Review of Available Water Temperature Data and Thermal Plume Characterizations related to the Merrimack Power Station in Bow, NH

December 11, 2017

1.0 Introduction

Figure 2. Water Temperature Measurements Collected Below Merrimack River Dams in July and August 2002 (Gomez and Sullivan, 2003, p. 78)

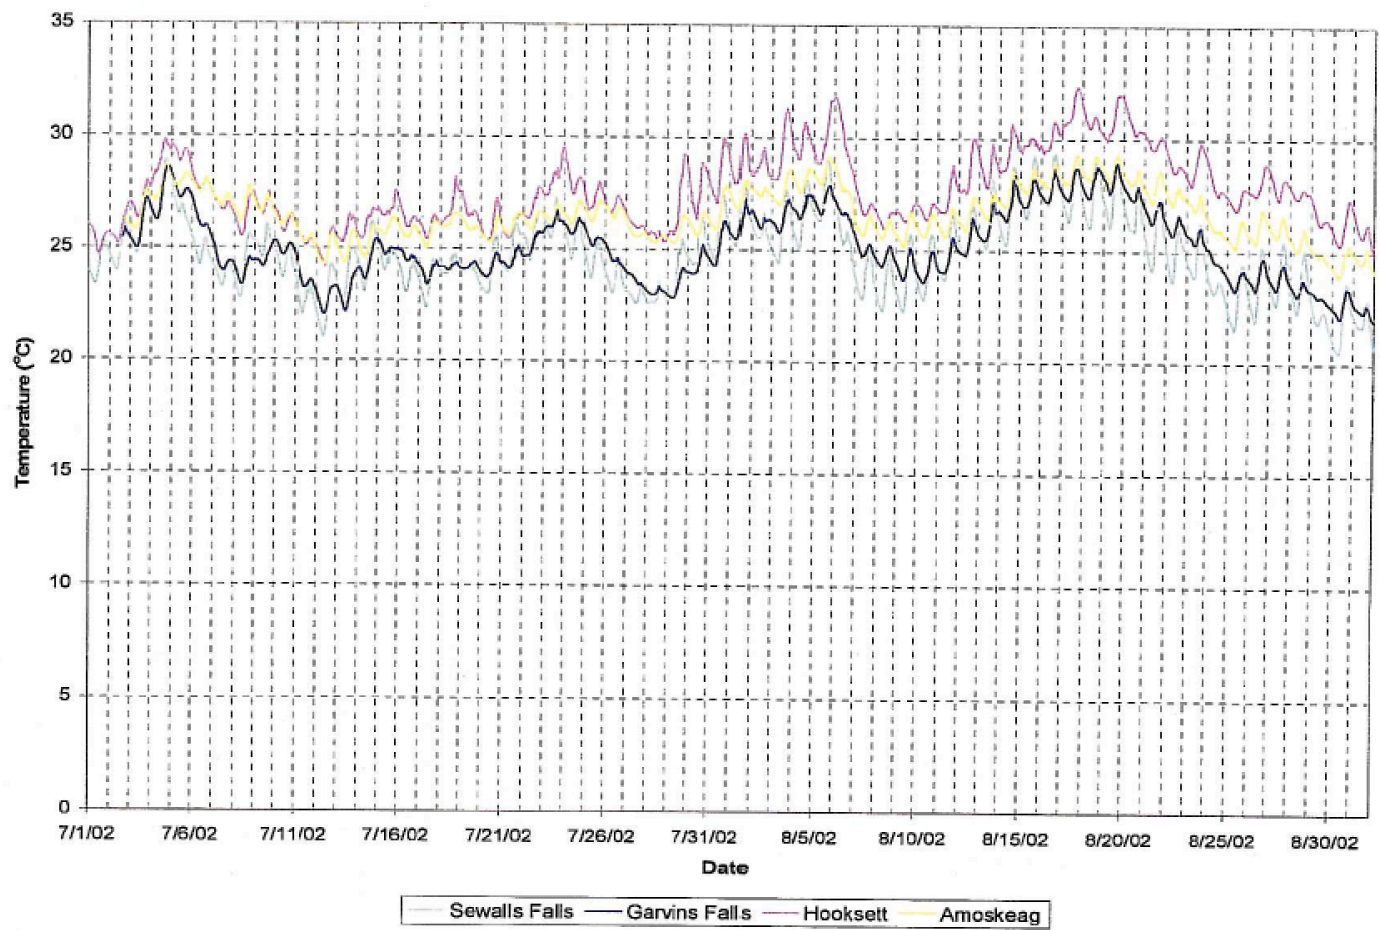
Water temperature was measured below four dams along the Merrimack River during the summer of 2002 as part of the Federal Energy Regulatory Commission (FERC) relicensing-related project (Gomez and Sullivan, 2003). Time-series plots of continuously-recorded (every 15 minutes) water temperature measurements are presented in the report (Gomez and Sullivan, 2003, pages 77-79). Figure 2 shows water temperature measurements in July and August 2002 and Figure 3 shows water temperature measurements in September and October 2002. Garvin's Dam (water temperature measurements shown in dark blue) is located 2.9 miles upstream of the Merrimack Station thermal discharge and Hooksett Dam (lavender) is located 2.9 miles downstream of the thermal discharge. The time-series plots show a typical increase in water temperature of 2 to 4°C (3.6 to 7.2°F) between Garvin's Dam and Hooksett Dam. On September 5th and 17th, the increase in water temperature was approximately 5.6°C (10°F).

The Hooksett Dam water temperature measurement location is downstream of the dam where thorough mixing of Hooksett Pool waters is expected to have occurred. As a result, the ΔT values observed between the Garvin's and Hooksett Pool Dams are average ΔT values for the entire water volume of the lower Hooksett Pool area, from the Merrimack Station discharge location to the Hooksett Dam, a distance of 2.9 miles. In summary, the Merrimack River dam water temperature measurements led to the observation that the average water temperatures in the lower Hooksett Pool were typically

increased by 3.6 to 7.2°F, with peak temperature increases of 10°F, during the summer of 2002. While elevated summertime air temperatures and solar heating could have contributed to these increases in river temperature, those contributions would have been minor and the majority of these temperature is likely due to the Merrimack Station discharge.

Figure 4. Daily Water Temperature Measurements at Four Monitoring Stations Compared to Selected Fish Tolerance Temperature Thresholds – July 2002

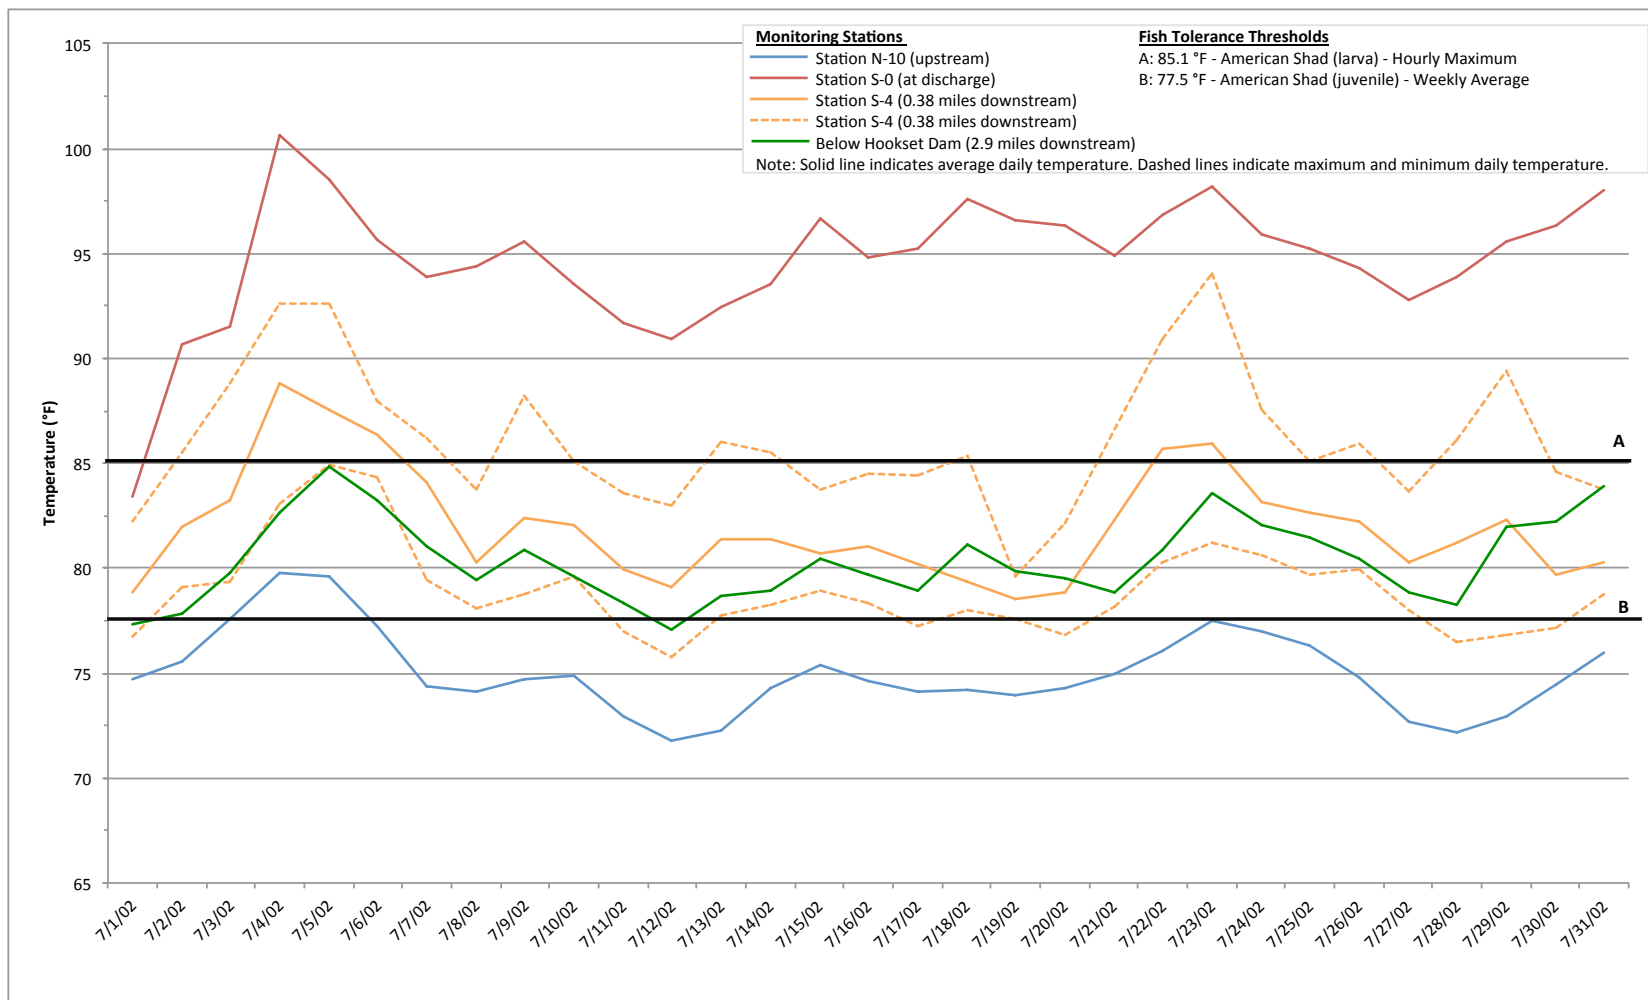
Figure 4 presents time-series plots of water temperature measurements collected in July 2002. Average daily upstream water temperatures (blue line) ranged from 72 to 79°F. Average daily Merrimack Station thermal discharge temperatures (red) ranged from 83 to 101°F and were typically between 91 and 98°F. The Merrimack Station ΔT between the upstream station, N-10, and Station S-0 was typically approximately 20°F. Average daily temperatures at downstream Station S-4 (orange solid line) ranged from 78 to 86°F. Daily maximum and minimum temperatures at Station S-4 are provided as dashed orange lines in Figure 4 and show that temperatures at Station S-4 vary throughout the day by 5 to over 10°F. PSNH's use of daily average statistics makes it impossible to determine the time period within each day that these variations occur (i.e., the rate of ΔT has been masked). The ΔT between the discharge location, S-0 and Station S-4, located 0.38 miles downstream, was typically 8 to 13°F. The ΔT between the downstream Station S-4 and the upstream station, N-10, was typically 5 to 10°F.

Hooksett Dam temperature measurements ranged from 77 to 85°F. The ΔT between the Hooksett Dam station and the upstream station, N-10, was typically 5 to 8°F.

Comparison of selected July fish tolerance thresholds to water temperature measurements reveals that the acute threshold for American Shad larva of 85.1°F (line A in Figure 4), which should not be exceeded for more than one hour, was exceeded for all but the first day of July at Station S-0. Other than on July 1, exceedances at Station S-0 are always greater than 5°F and often exceed 10°F. The acute Shad tolerance was also exceeded by the maximum temperature observed at downstream Station S-4 on 17 of 31 days in July 2002, showing that exceedances extended at least 0.38 miles downstream.

The average weekly threshold of 77.5°F for juvenile American Shad (line B in Figure 4) was exceeded by the daily average temperature at Station S-0 and S-4 every day (and thus every week) of July 2002. The average weekly American Shad threshold was also exceeded nearly every day (and thus every week) at the Hooksett Dam, 2.9 miles downstream. Since there is complete mixing below the Hooksett Dam, the exceedance of the average weekly American Shad threshold below Hooksett Dam indicates that this threshold was exceeded throughout the entire lower Hooksett Pool area (a 2.9-mile reach).

Figure 5. Daily Water Temperature Measurements at Four Monitoring Stations Compared to Selected Fish Tolerance Temperature Thresholds – August 2002

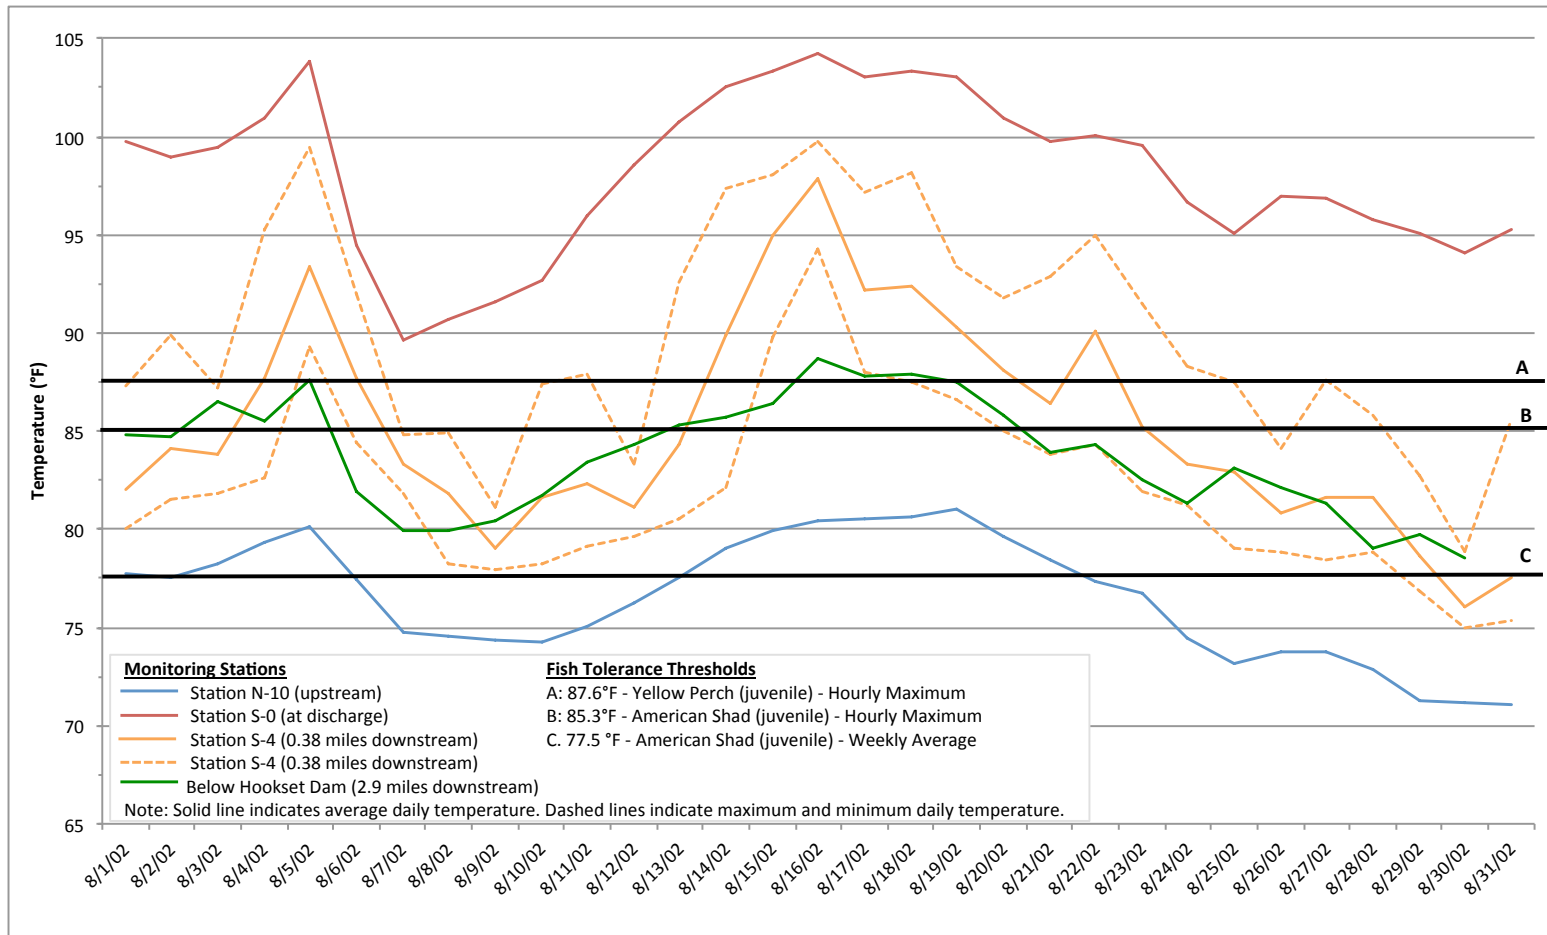
Figure 5 presents August 2002 water temperature measurements and selected applicable fish tolerance thresholds. In August 2002, the acute criteria for Yellow Perch and American Shad (lines A and B in Figure 5) exceeded the daily average temperature at Station S-0 during the entire month. The acute criterion for American Shad at Station S-0 was exceeded by a maximum of 18.9°F on August 16th. Acute American Shad criterion also exceeded maximum daily temperature at Station S-4, 0.38 miles downstream, on 24 of 31 days in August 2002. Acute American Shad criterion also exceeded temperatures below the Hooksett Dam, 2.9 miles miles downstream, on August 13 through 16, indicating that all of lower Hooksett Pool exceeded the acute criteria thresholds during this period of time. The average weekly threshold for American Shad was exceeded at Stations S-0, S-4 and at Hooksett Dam for the entire month of August 2002.
